Plat Num: 20-059

Cumberland County Subdivision and Land Development Review Report

Municipality:	Middlesex	Surveyor/ Engineer:	Rettew Associates	Owner/ Developer:	Keystone Arms Phase Two
Plat Title:	Keystone Arms - Middlesex Twp				
Plat Status:	Final			Plat Type:	Subdivision
# of New Lots:	7	# of New Dwelling Units:		New Acreage Subdivided/Developed:	17.96
Total Tract Acreage:	49.4				
Zoning District:	VC			Proposed Land Use:	Residential
Date Received:	3/30/2020	County Review:	4/17/2020	Reviewed by:	EG
Checked by:

COVER SHEET
FINAL MAJOR LOT CONSOLIDATION SUBDIVISION
FOR
KEYSTONE ARMS

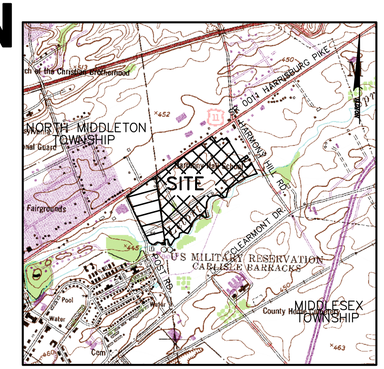
4. The dwelling units described in the Lot Area Tabulations refer to townhouse units. It appears that Lot 272 includes apartment units within the housing units. The existing apartments should be referenced in the dwelling type column.

5. The Zoning Data table on the cover sheet should include required side setbacks for corner lots and address parking requirements and provisions. (Zoning, 14.38 B.3 and 14.38.C, SALDO 501.A.21)
